Certificate of Appropriateness

Property	2913 N. LAKE DR. North Lake Drive Historic District
Description of work	Replace glass block window on second floor of rear elevation with a new double hung, divided lite wood window in cottage style to match originals. The window presently is under orders from the Department of Neighborhood Services because the glass block was installed without a COA. Replace one set of casement windows in rear dormer (r.o. 26-1/2" x 36-3/4") with new all-wood casement window to match original profiles. Replace two sets of divided-lite casement windows in dormers on north elevation with new wood windows to match original molding profiles and glass sizes.
Date issued	9/12/2013 PTS ID 89935 COA, selective window replacement

Vertical Mullion - LVL Operator/Operator

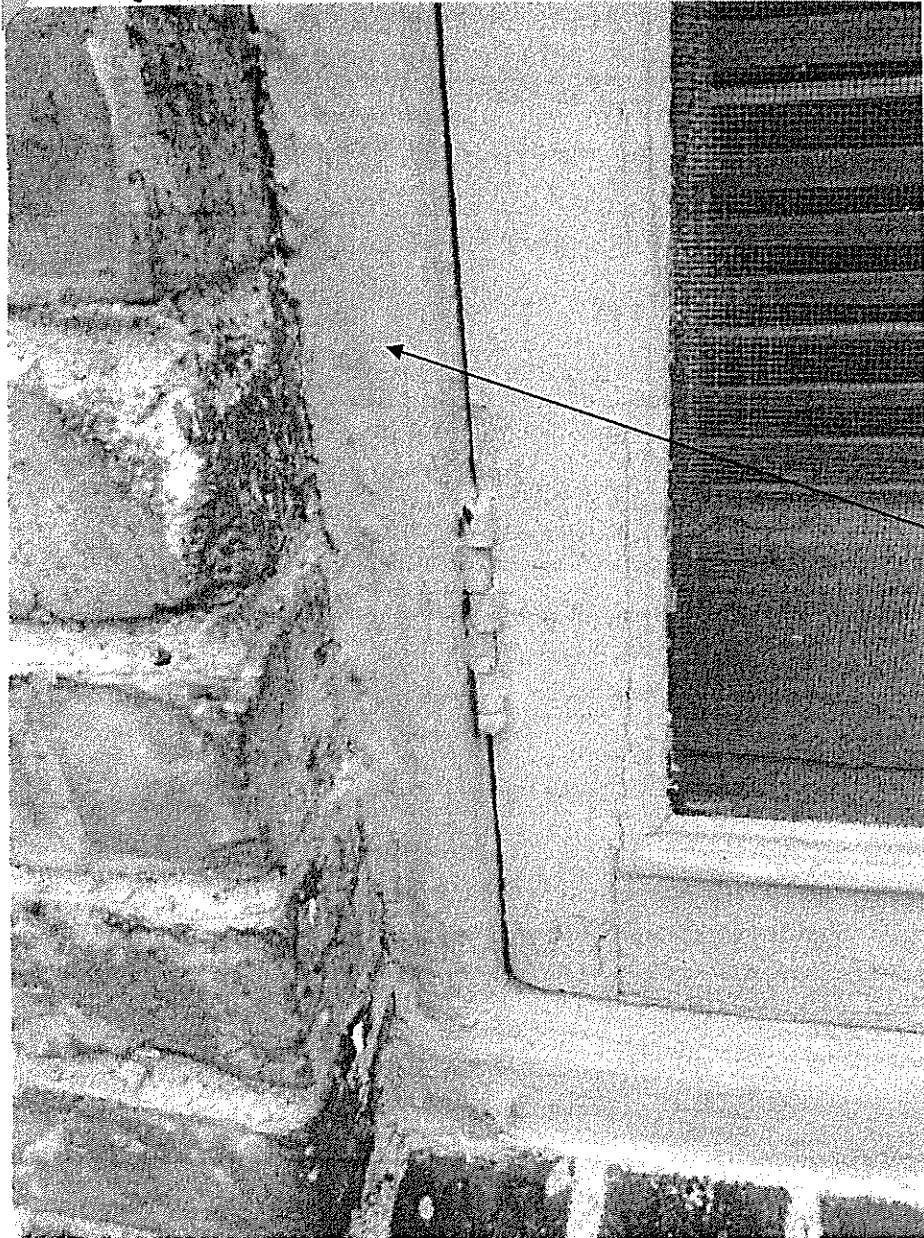
Section of casement windows to be installed showing required mullion between the windows to match the original design. New windows must duplicate all the details of the original windows they are replacing

Olding example for windows, Custom

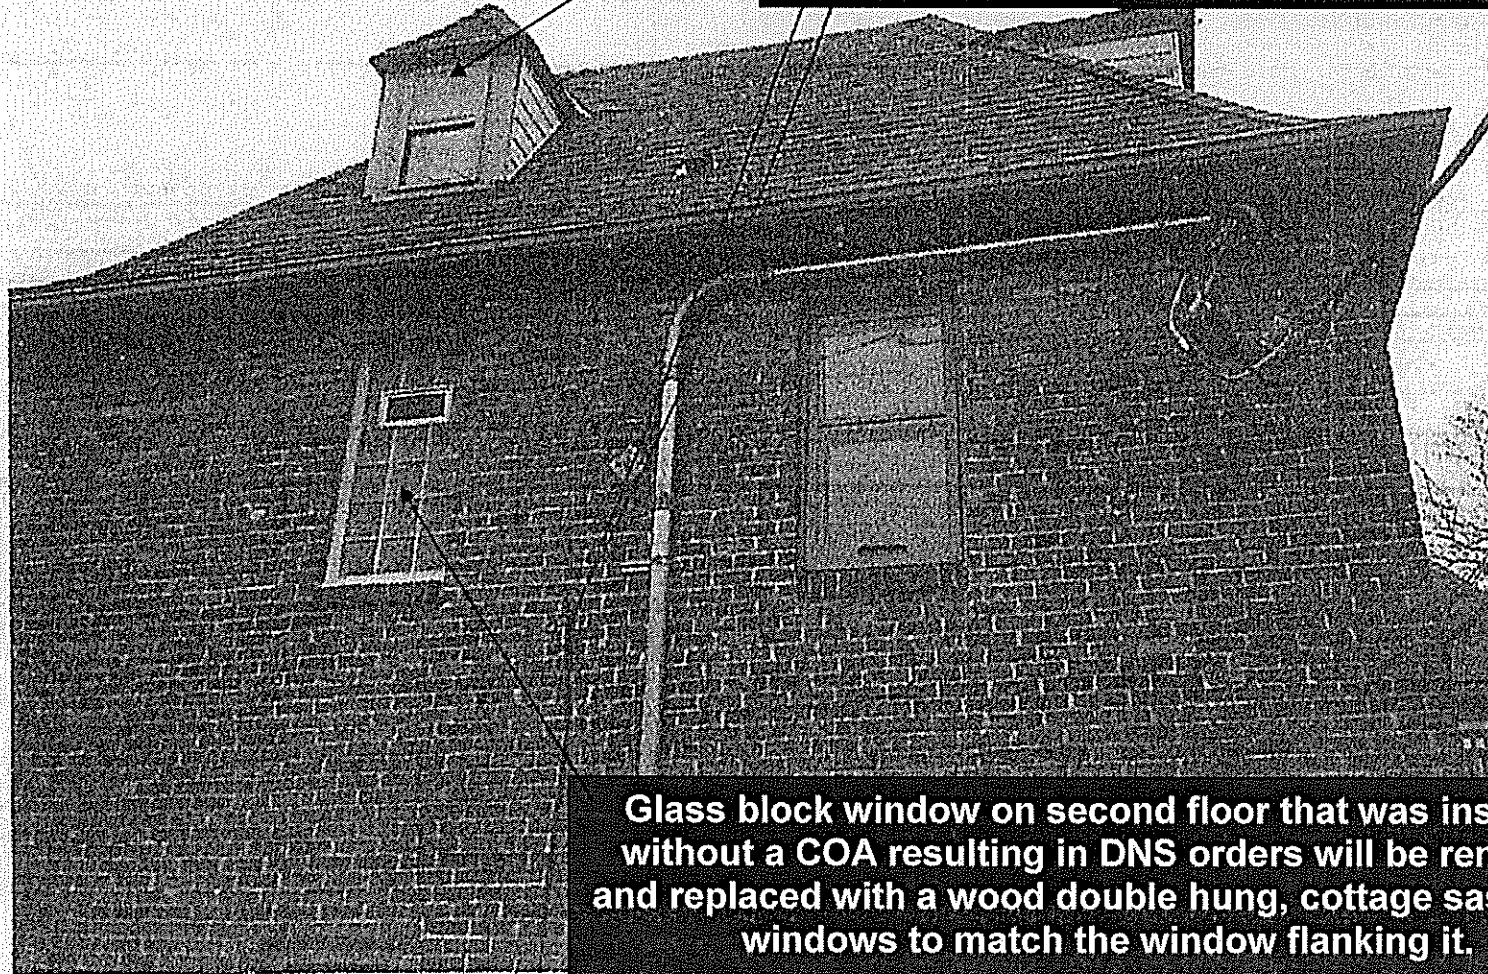
Original brick molding to be stripped to bare wood and then used as a pattern to make new wood brick moldings to match and then install around new windows.
